CITY OF ALBUQUERQUE

RE: Lot 7 Block 1 Volcano Cliffs SAD 227 6623 Rim Rock NW

Grading and Drainage Plan

Engineers Stamp Date 9/8/17 (D10D010)

GRADING AND DRAINAGE PLAN

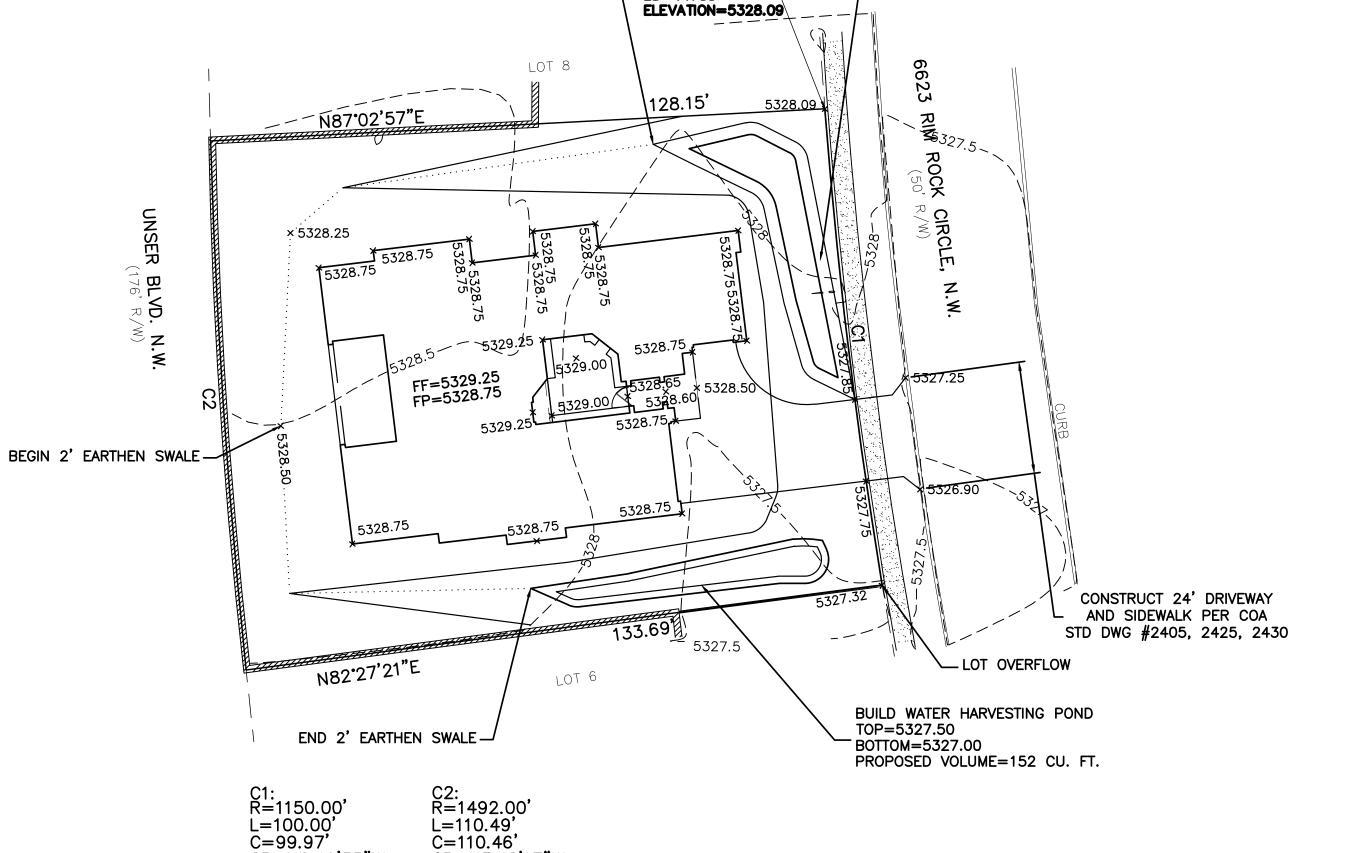
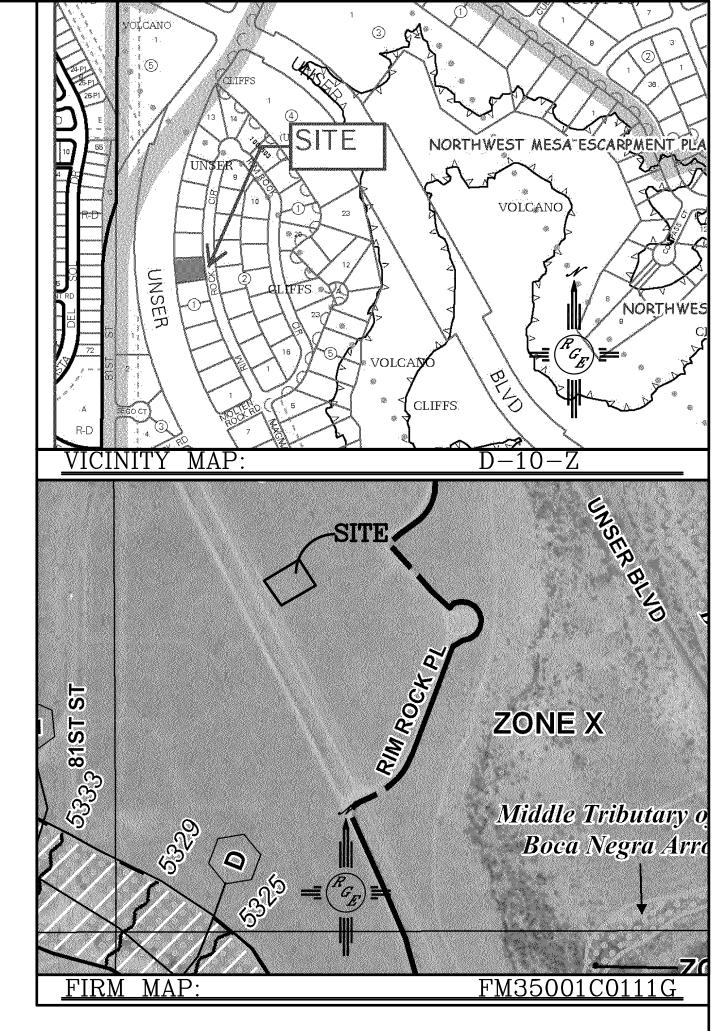
Based upon the information provided in your submittal received 9/11/17, this plan is approved for Grading Permit.

Prior to Building permit approval a Pad Certification will be required, provided by the Engineer or a registered Land Surveyor.

Reiterate to the Owner/Contractor that a separate permit for a garden/retaining wall must be obtained, with the approved G&D plan dated 9/8/17.

Prior to Certificate of Occupancy release, Engineer Certification per the DPM checklist of this plan will be required.
